ADDENDUM NO. 1 DATE: October 12, 2011

Contract 11-C-00049; Drew Park Stormwater Pond Improvements, Phase 1

Exhibit 1

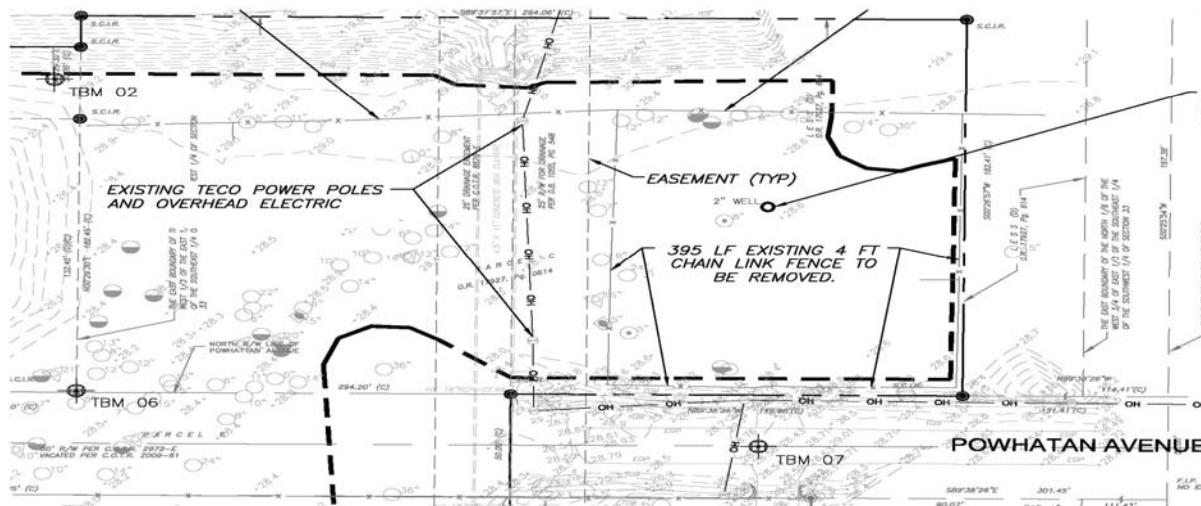
SP-43 POWER POLES

The Contractor shall be aware that there are two (2) existing TECO power poles and an overhead electric power line located in the northeast area of the project site. This area is not within the pond expansion area, but there is clearing and grubbing associated with this area. The Contractor shall exercise caution when working in this area. Future plans for relocation of the poles and power lines are anticipated, but actual dates of removal by TECO are unknown. An exhibit of the power pole and overhead electric power line locations can be seen below in Exhibit 1.
